Certificate of Appropriateness

2542 N Terrace Avenue

Tuckpointing, in-kind garage door replacement, fascia and soffit repair/replacement, gutter and downspout replacement, back porch step and deck replacement.

11/03/2021

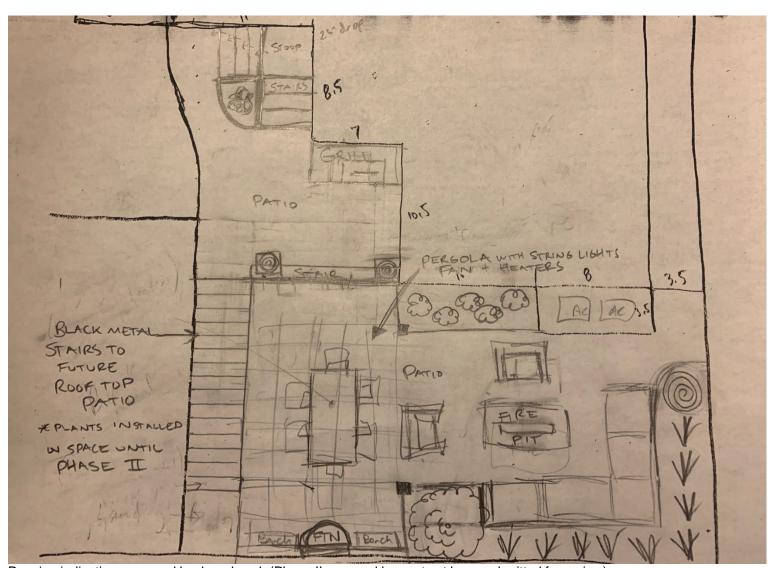
Drawing indicating proposed backyard work (Phase II proposal has not yet been submitted for review).
